# UNITED STATES PATENT AND TRADEMARK OFFICE

APPLICATION NO.	FILING DATE	FIRST NAMED INVENTOR	ATTORNEY DOCKET NO.	CONFIRMATION NO.
10/707,619	12/24/2003	Aaron Golle	1748006US1	1478

**Office Action Summary**

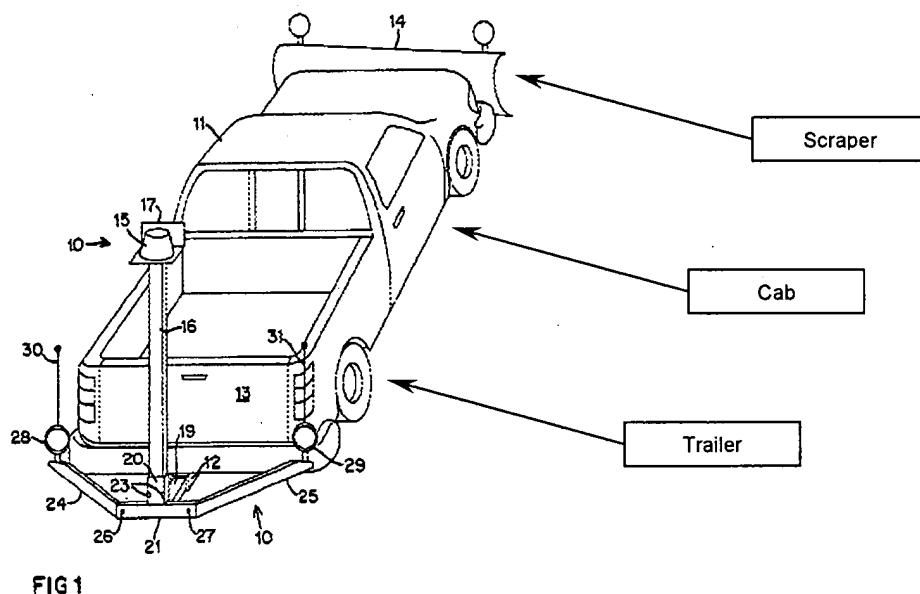
Pratt teaches a warning light for a vehicle, whereby the vehicle is a snowplow including a cab, trailer, and scraper [Figure 1 – note drawing below].

It would have been obvious to one ordinarily skilled in the art at the time of invention to incorporate the EL lighting device of Hoffman onto the cab of a snowplow of Pratt, in order to convey a message [e.g., safety or warning] or enhance visibility to other individuals/vehicles of the presence of the snowplow, and thus, enhance overall safety and prevent an accident. It should be noted that it is commonly known and obvious within the art to use signs on large vehicles to increase awareness of drivers and avoid accidents.
